**ZONING AMENDMENT
& SUBDIVISION STAFF REPORT**

Date: June 19, 2014

Heroes USA Subdivision

36 & 48 Hillcrest Road
(West side of Hillcrest Road, 110'± South of Old Shell Road)

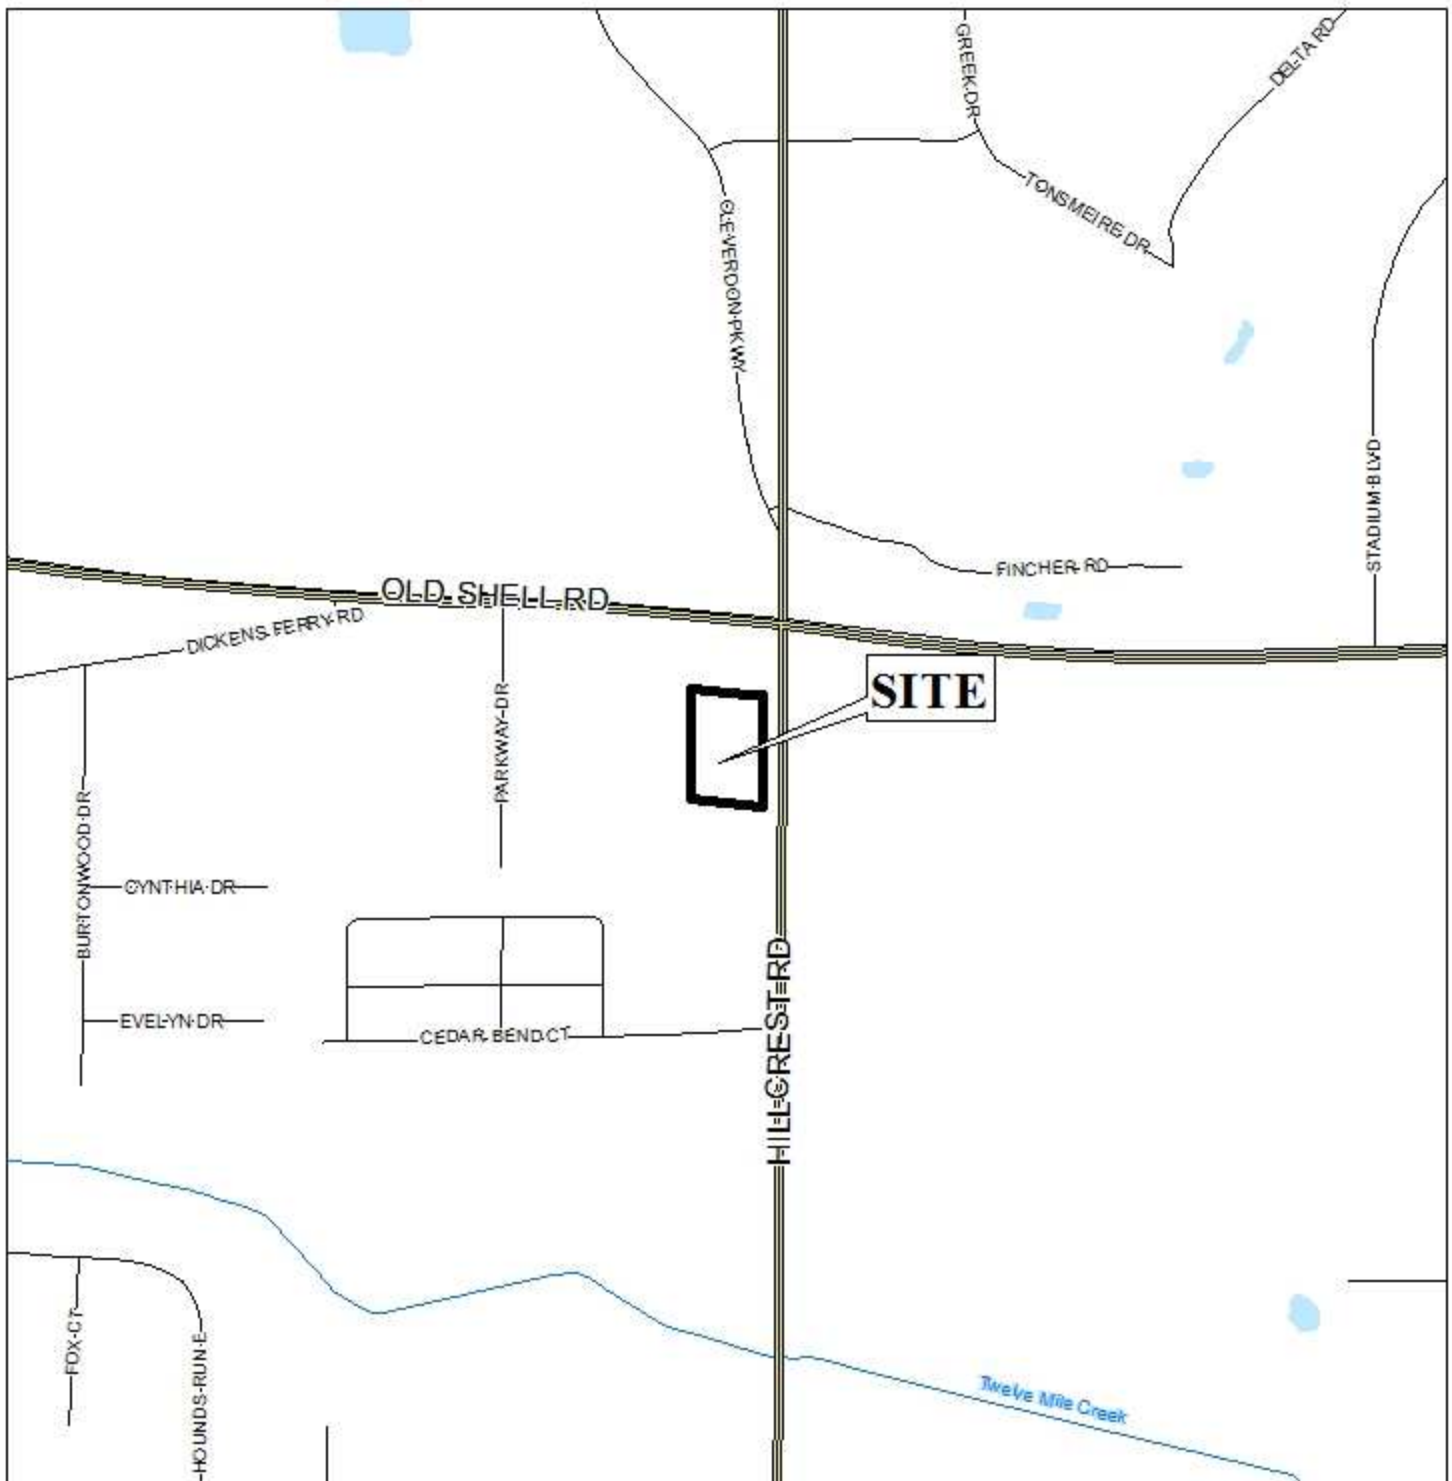
Recommend increasing the green space to a minimum of 5 feet from the trunk of the existing 36" Live Oak Tree located on the North portion of the development next to existing building. Currently the asphalt is paved to the trunk of the tree.

While approval of a rezoning request is not site plan specific, there are a few items that should be addressed. First, it appears that the dumpster enclosure will be within the required 10-foot wide residential buffer, thus it should be relocated to a compliant location. A residential protection buffer must be provided along the South and West sides of the property. It appears that the width of the parking spaces vary, however, all spaces including accessible spaces must be at least 9 feet wide and 18 feet long. It also appears that the accessible parking spaces and required access aisles may not comply with the requirements of the 2009 International Building Code (and, by reference, ANSI 117.1). No bumper stops or curbing are depicted on the site plan, however, bumper stops or curbing will be required where the parking area abuts a landscape area or property line. No new lighting is depicted on the site plan, however, lighting compliant with Section 64-6.A.8. of the Zoning Ordinance: a photometric plan will be required at the time of submission for land disturbance permits. There is no on site surface storm water detention depicted on the site plan. And finally, landscape area information is provided, but tree compliance information is not provided.

The preliminary plat shows that the residential structure will be removed from the property prior to construction of the parking lot. The structure should be removed, with the appropriate permits, prior to the signing of the final plat.

The 25-foot minimum building setback is depicted, and should be retained on the final plat, if approved.

- 1) Completion of the Subdivision process;
- 2) Compliance with Urban Forestry comments (*Property to be developed in compliance with state and local laws that pertain to tree preservation and protection on both city and private properties (State Act 61-929 and City Code Chapters 57 and 64). Increase the green space to a minimum of 5 feet from the trunk of the existing 36" Live Oak Tree located on the North portion of the development next to existing building – removing the asphalt paved to the trunk of the tree.*); and
- 3) Full compliance with all municipal codes and ordinances.
